2008-042

COLISEUM CENTRE PARKING DECK
CB RICHARD ELLIS

BUFFER GRADING EXHIBIT

DATE: November 10, 2011
TO: Mark Fowler
 Zoning Supervisor
FROM: Debra Campbell
 Planning Director
SUBJECT: Administrative Approval for Petition No. 2008-042 Crescent Resources, LLC

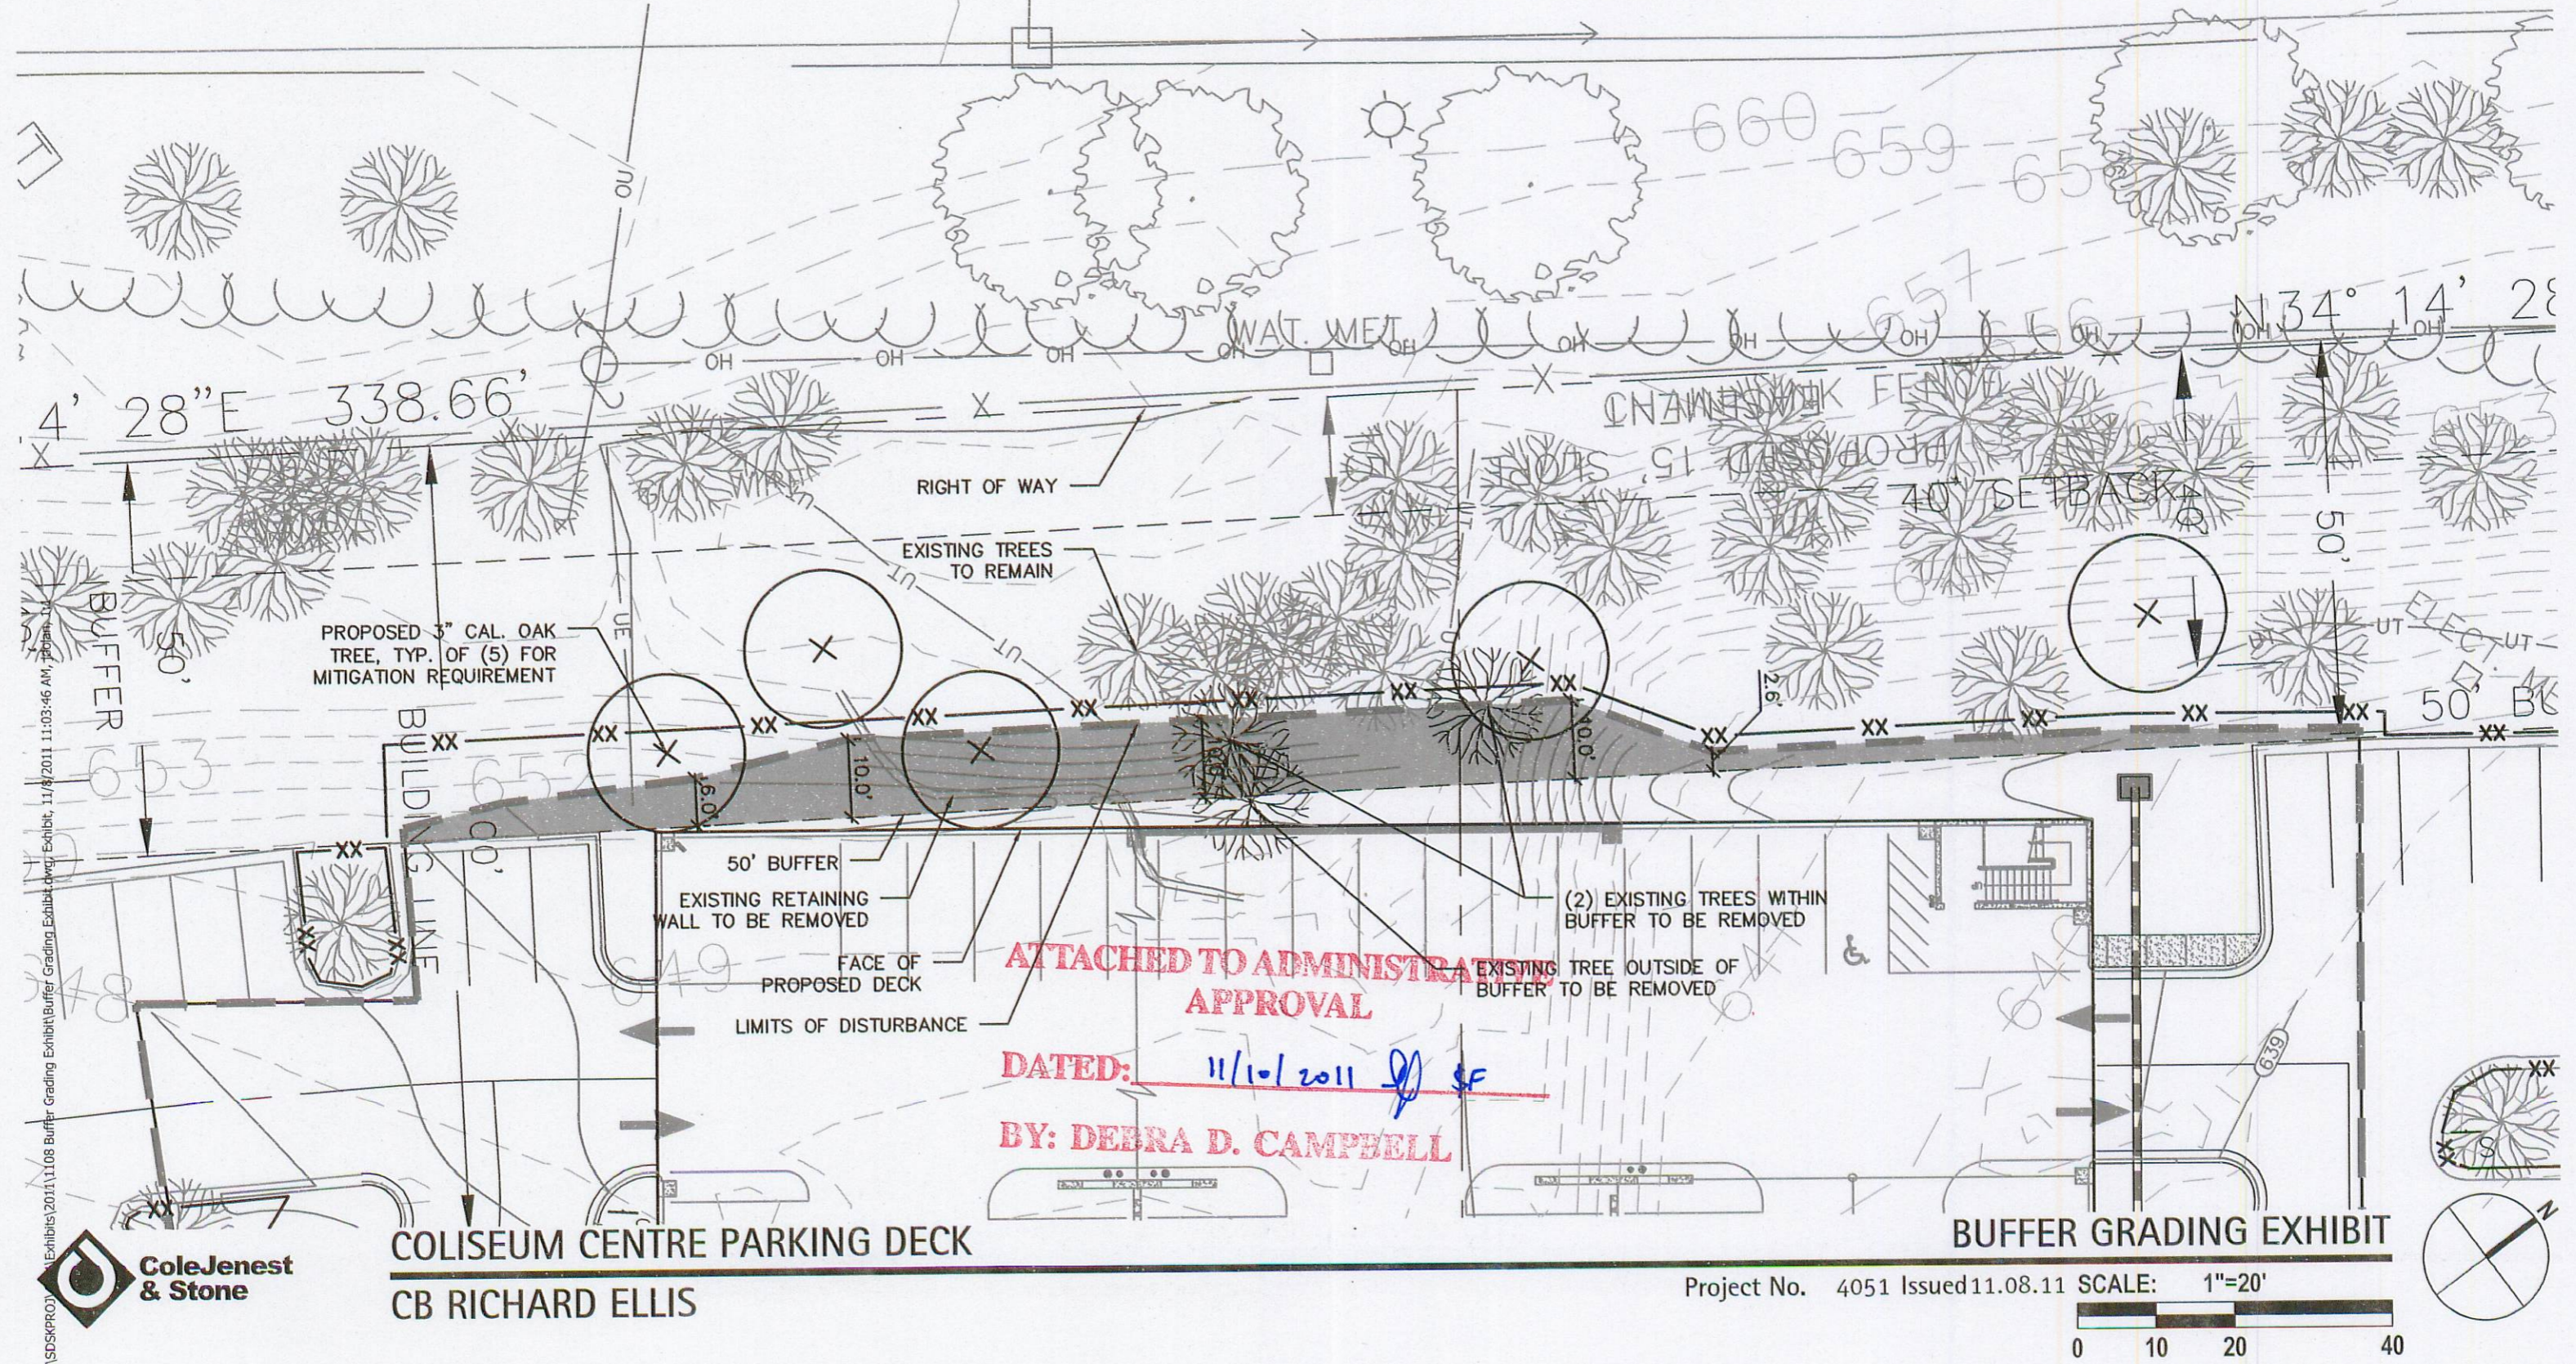
Attached is a revised site plan for the above referenced rezoning petition. The site plan shows the proposed mitigation for grading and tree mitigation in the undisturbed buffer section for construction of a new parking deck. Since this change does not alter the intent of the development and meets the requirements of the Charlotte Zoning Ordinance Section 6.207 Alterations to Approval, minor changes, I am administratively approving this plan. Please use these plans when evaluating requests for building permits and certificates of occupancy.
